- Proposed design changes following consultation:**
- 1 An additional on-street parking space is provided on Harewood Road outside the Featherstone Dairy. This is designated P5.
 - 2 Two additional on-street parking spaces are provided on Harris Crescent (west), one on each side of the road.
 - 3 On the western side of Harris Crescent (west) at Harewood Road, two spaces are designated P10. On the eastern side, the length between Harewood Road and the first driveway is designated P10.
 - 4 Two P5 (Monday to Friday) spaces are designated outside the Harewood Road Medical Centre.

- Proposed design changes following consultation:**
- 1 A pedestrian refuge island is added on Harewood Road near Wilmot Street. A portion of cycleway is narrowed to fit the pedestrian island.
 - 2 The proposed cul-de-sac at Wilmot Street is shifted to the intersection with Hoani Street. This provides two additional on-street parking spaces on Wilmot Street outside Palmer Funeral Services.
 - 3 The proposed P120 parking restrictions on Wilmot Street are changed to P180.

Proposed design changes following consultation:

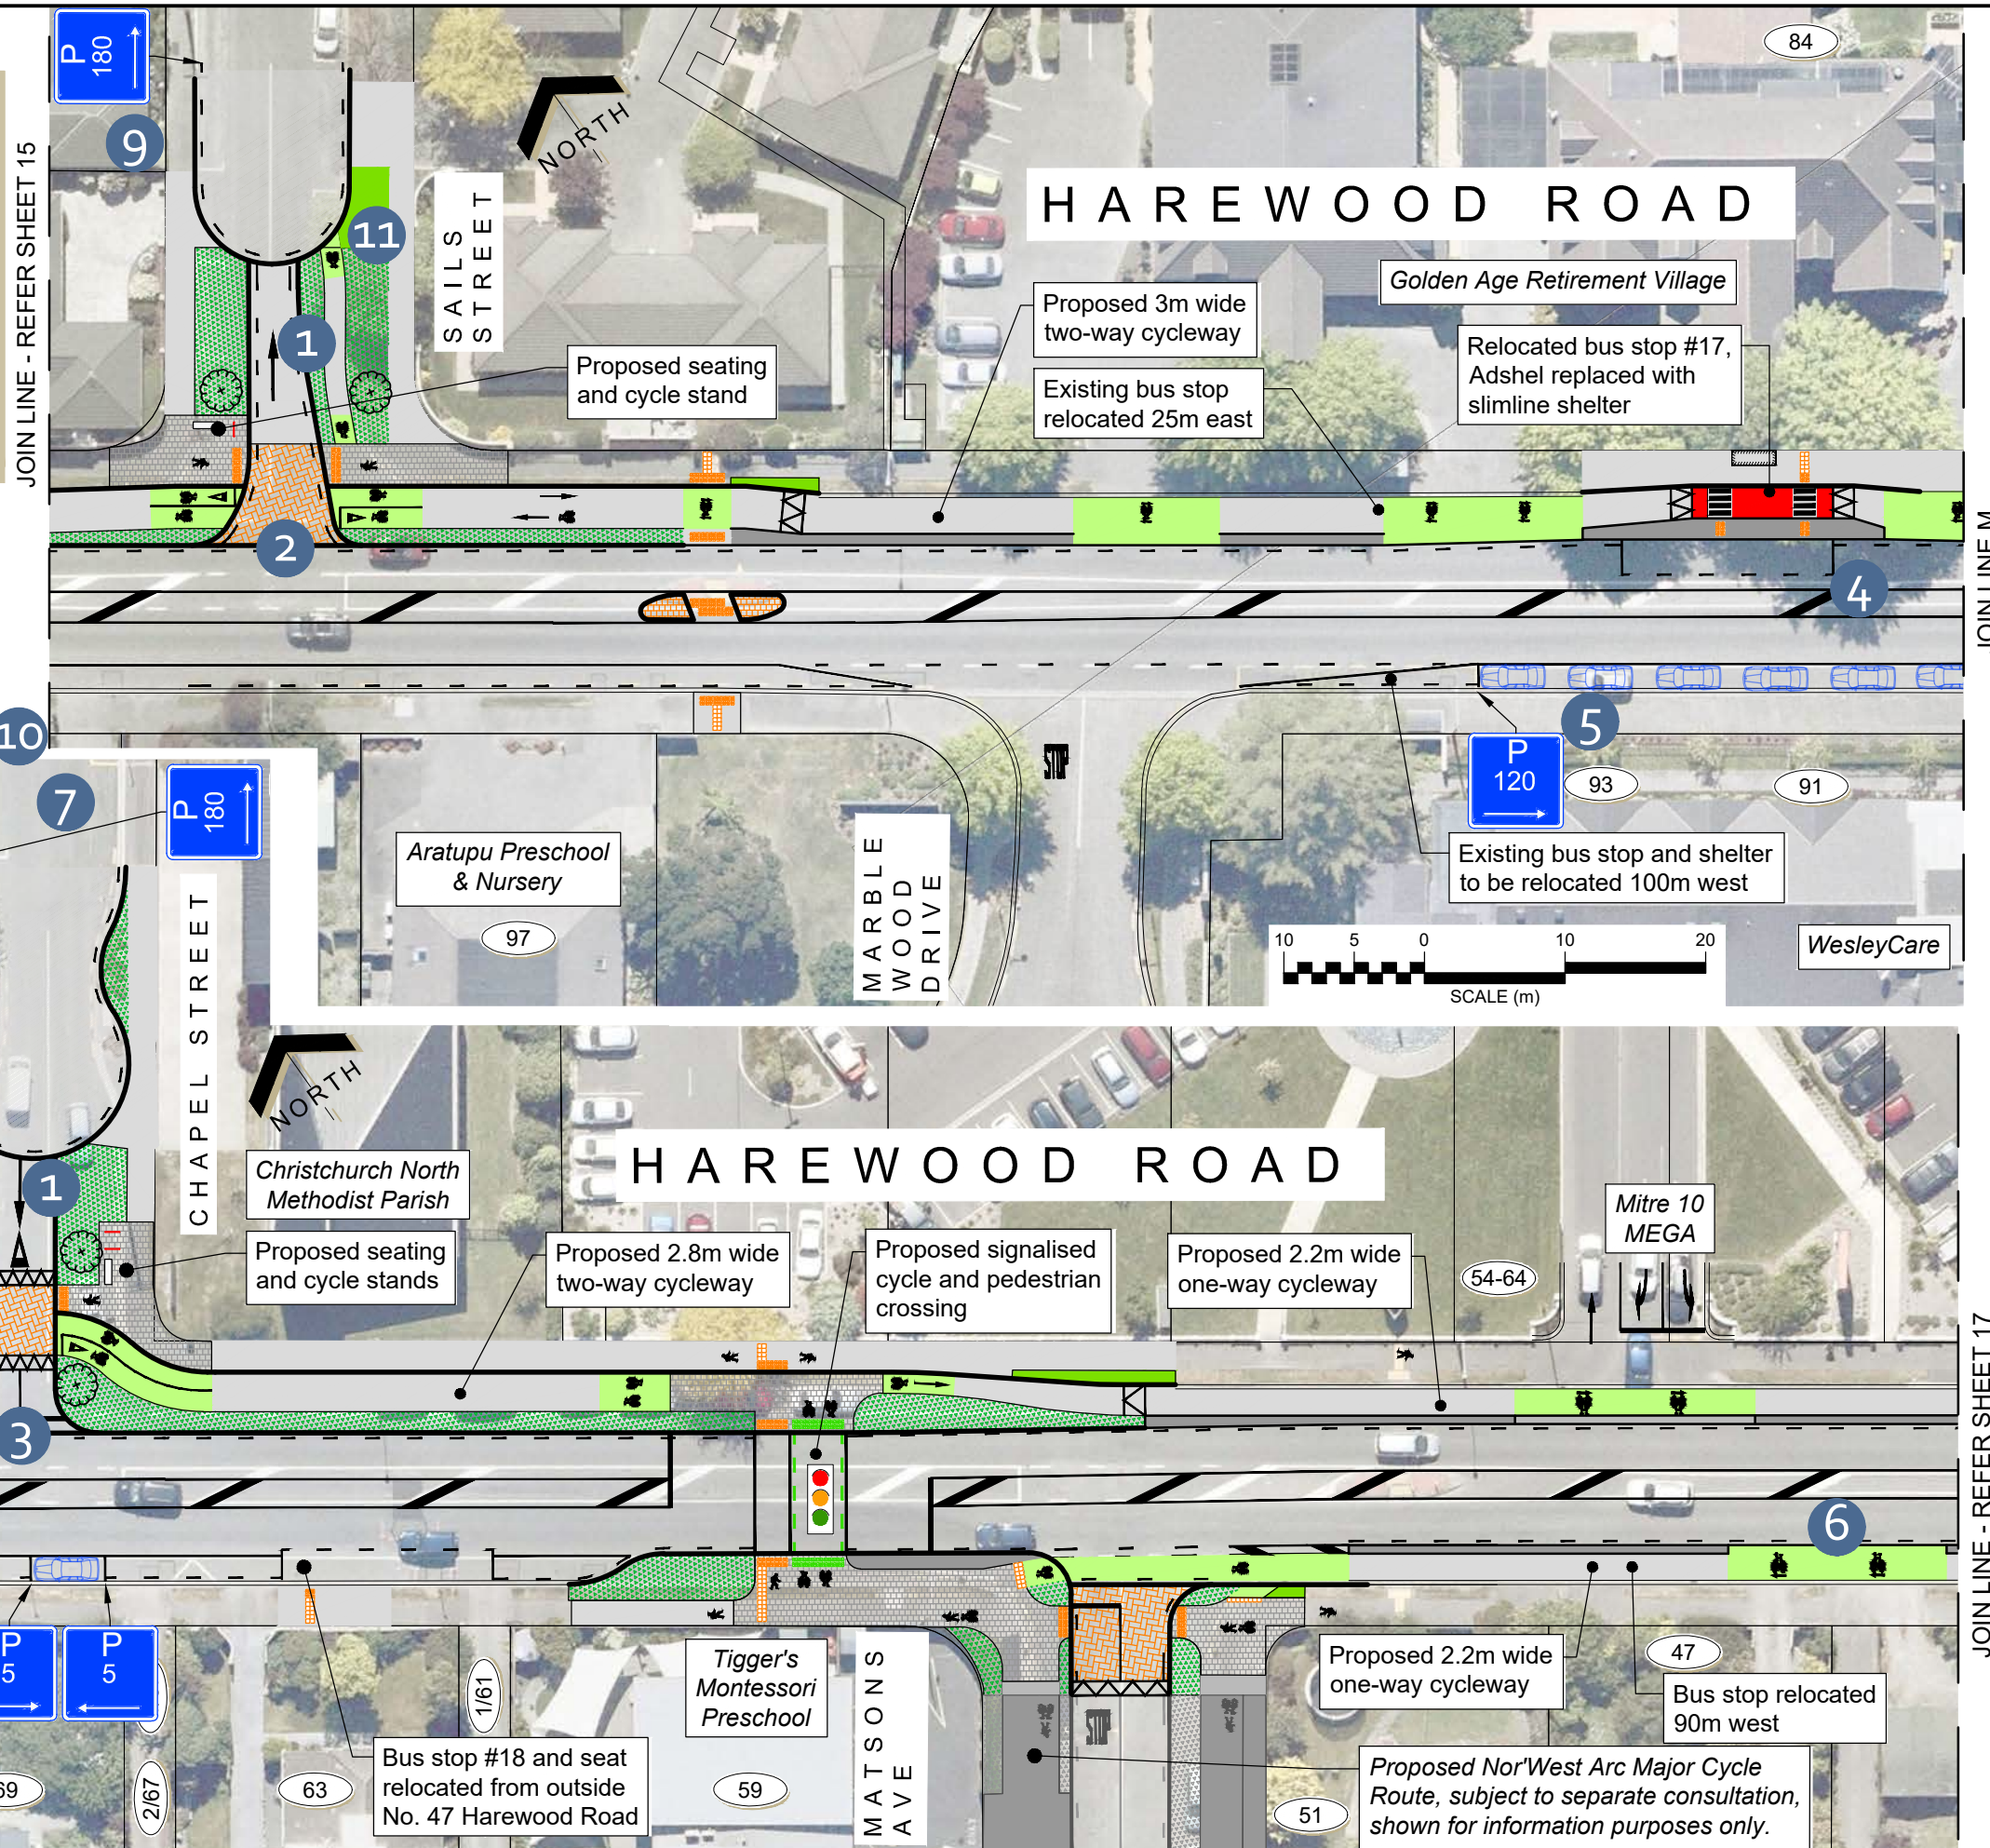
- The proposed vehicle access restrictions at the intersections of Chapel Street and Sails Street with Harewood Road are swapped. Sails Street becomes entry only off Harewood Road, Chapel Street becomes exit only onto Harewood Road.

- The entrance onto Sails Street from Harewood Road is widened, making it easier for larger vehicles to negotiate the corner.
- The exit onto Harewood Road (now from Chapel Street) is widened, allowing two vehicles to sit side-by-side.

- The bus stop outside Golden Age is indented further, providing more space for traffic to pass a stopped bus.
- The proposed P60 parking restrictions outside Wesley Care are changed to P120.

- The driveway opening in the cycleway separator at No. 41/47 Harewood Road is lengthened.
- The proposed P120 parking restrictions on Chapel Street are changed to P180.

- The existing P120 parking restrictions on the western side of Chapel Street are changed to P180.
- The proposed P120 parking restrictions on Sails Street are changed to P180.

- Some on-street parking on Chapel Street (5 spaces) and Langdons Road (2 spaces) are proposed to be removed at the intersection of these two roads. This will prevent right-turning vehicles holding up following traffic and will make access easier for larger vehicles.

- The design of the turning head of Sails Street is adjusted to allow the tree to be retained.

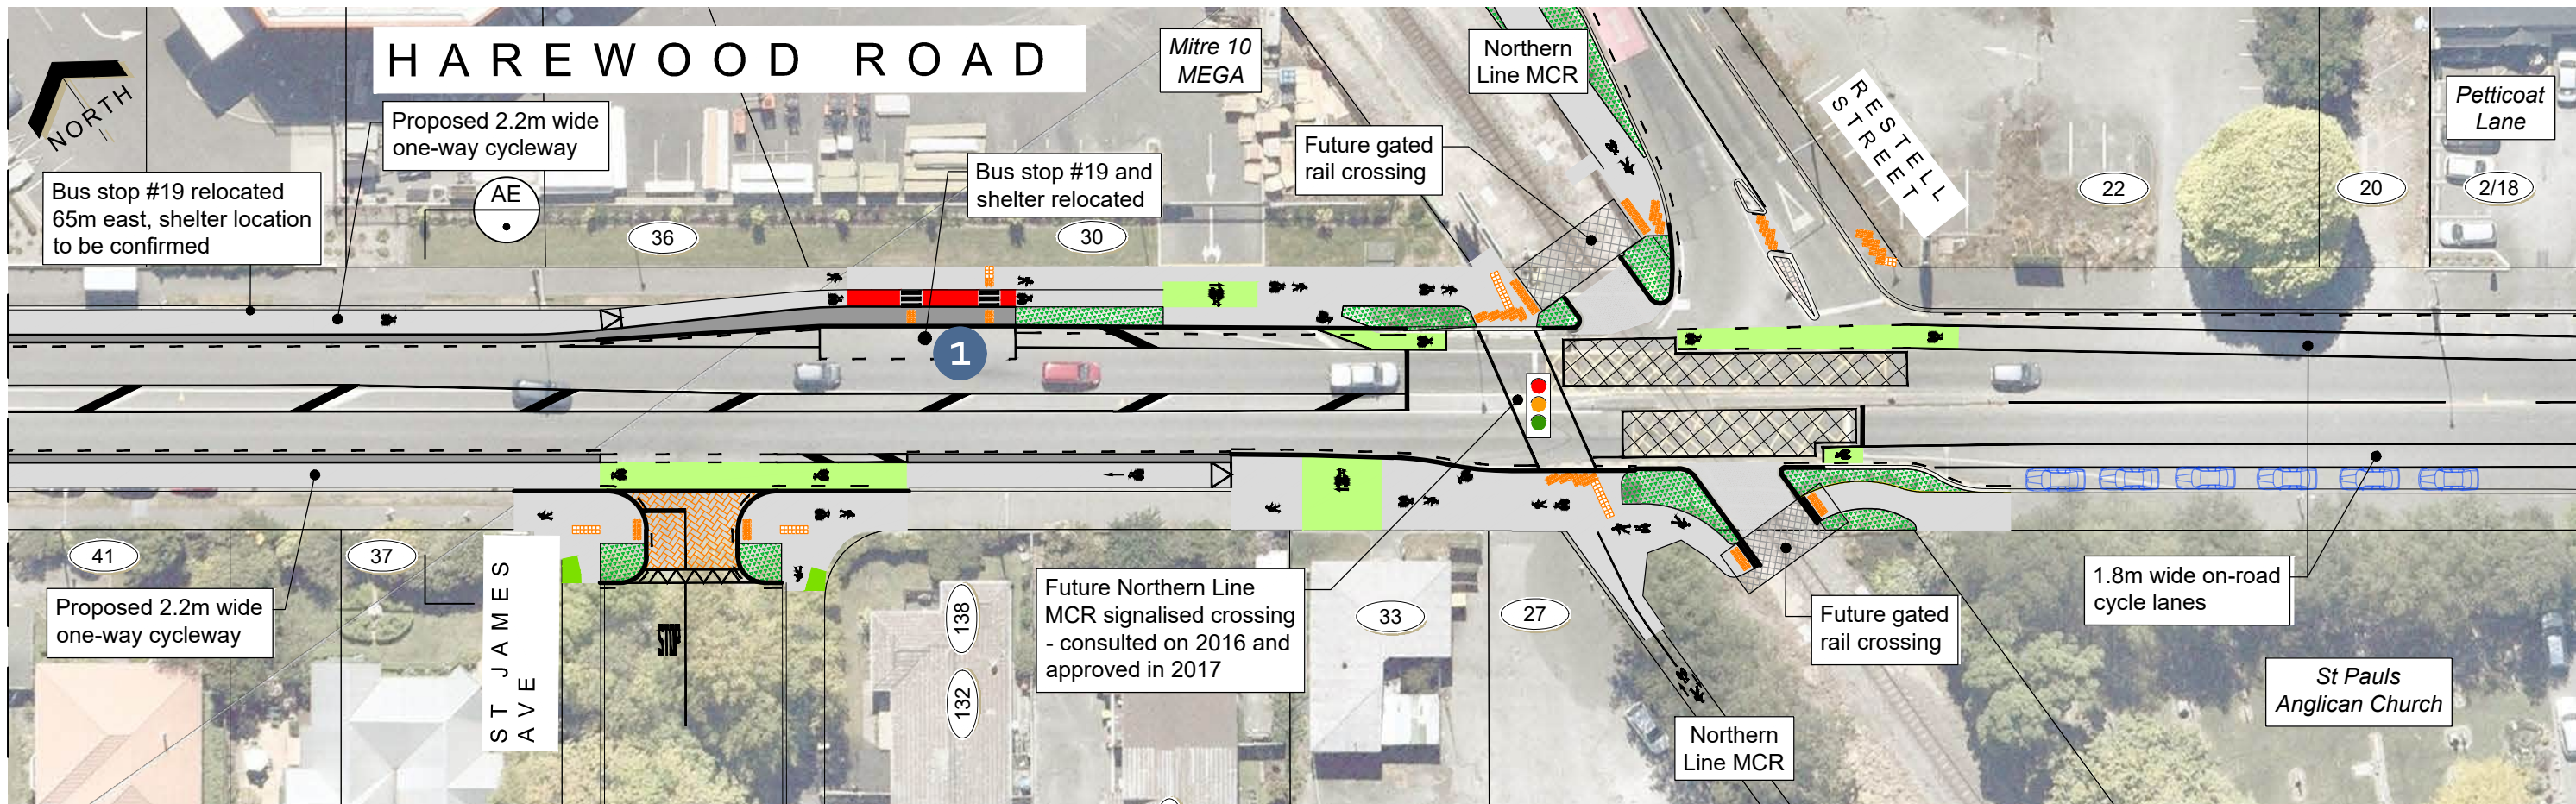
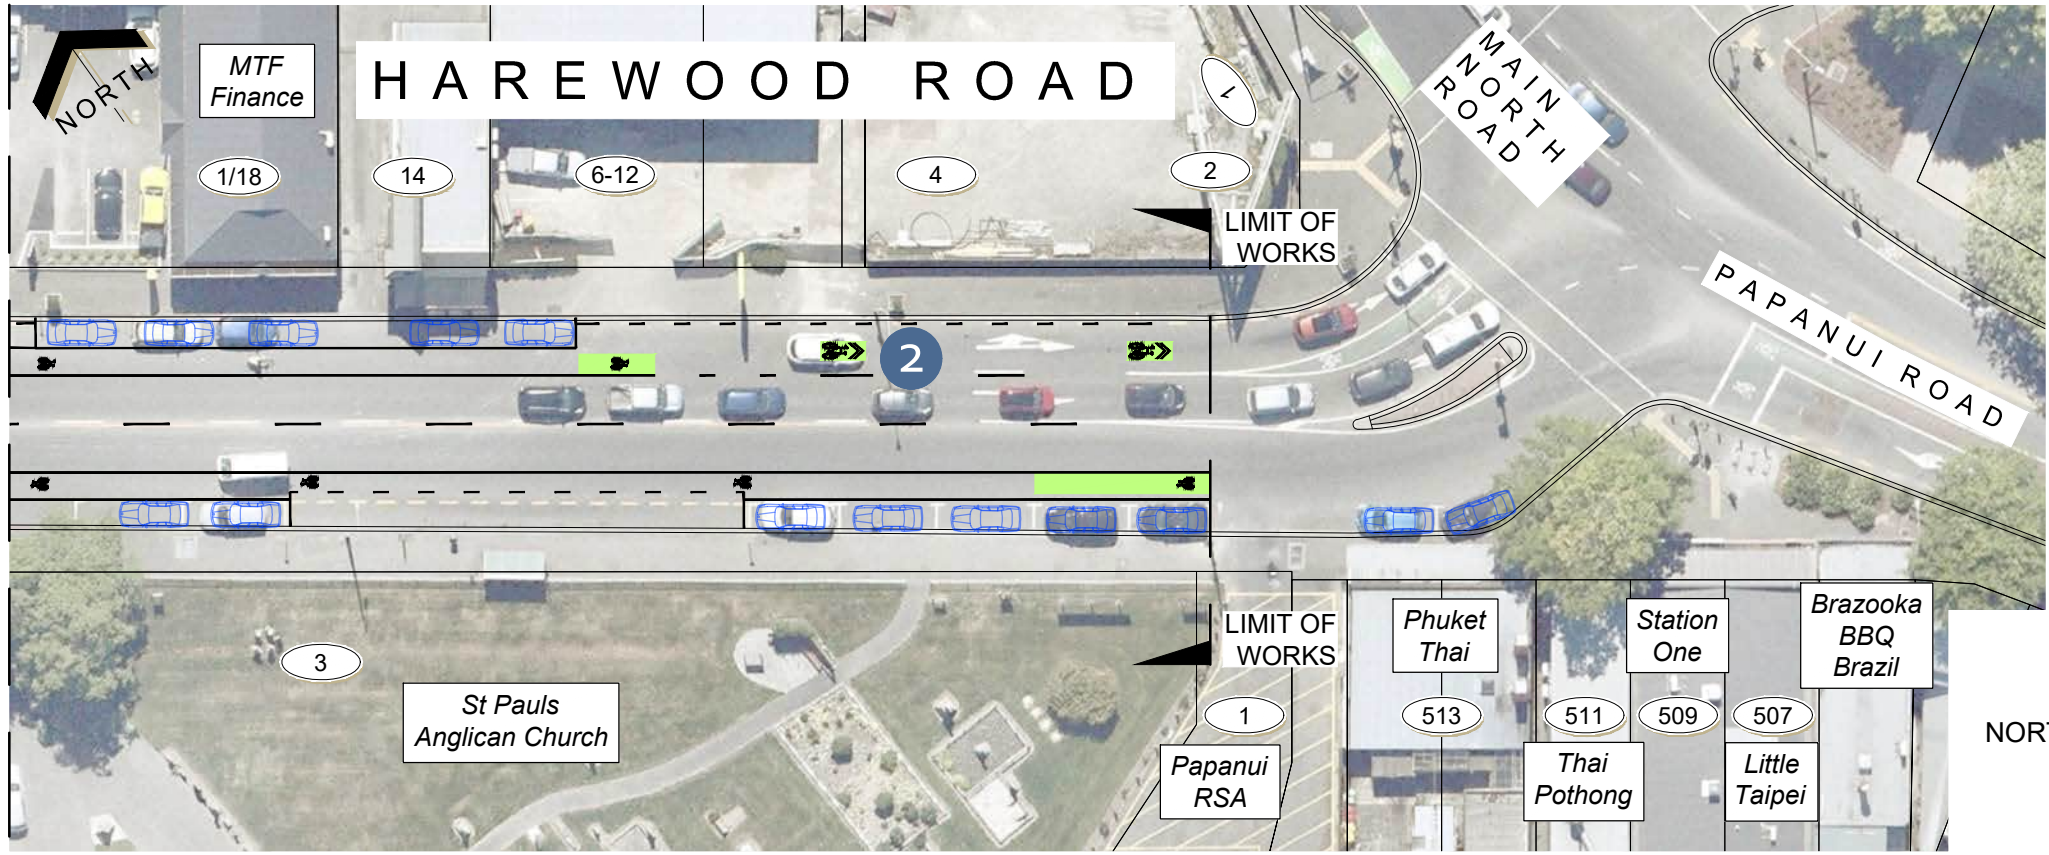
Proposed design changes following consultation:
1 The eastbound bus stop outside Mitre 10 is indented and shifted to 65 m east of its existing location.
2 Additional cycle markings are added approaching Main North Road.

Proposed design changes following consultation:

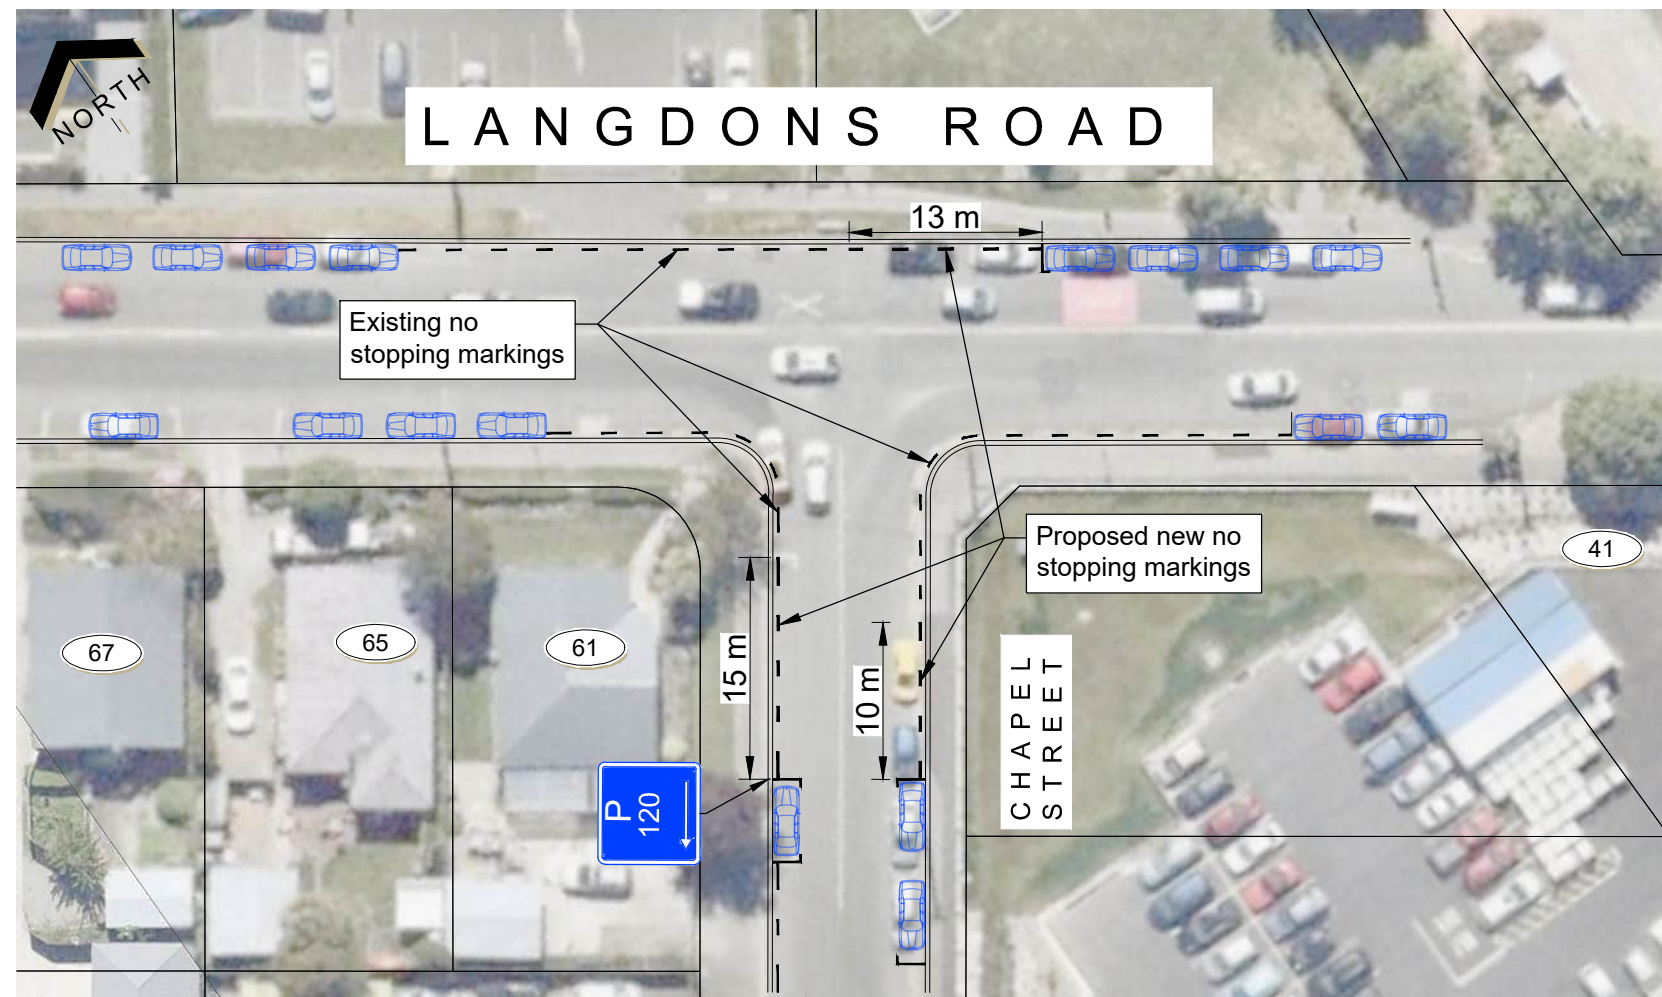
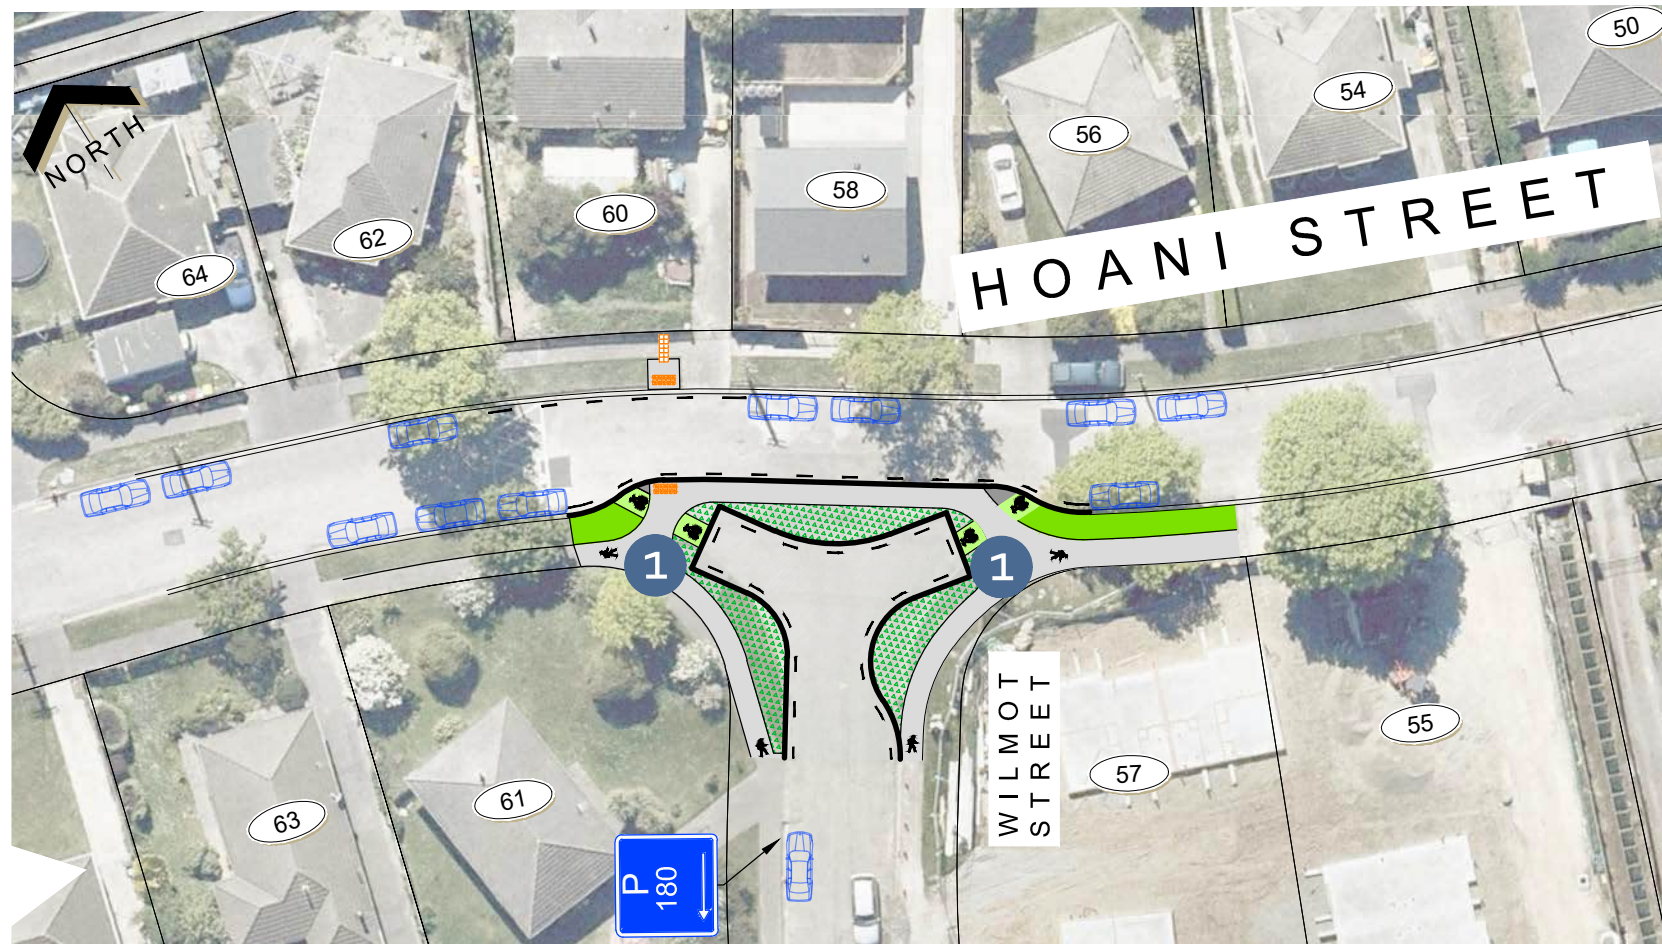
1 The shared path areas where Wilmot Street intersects with Hoani Street are replaced with direct cycle connections to the roadway.
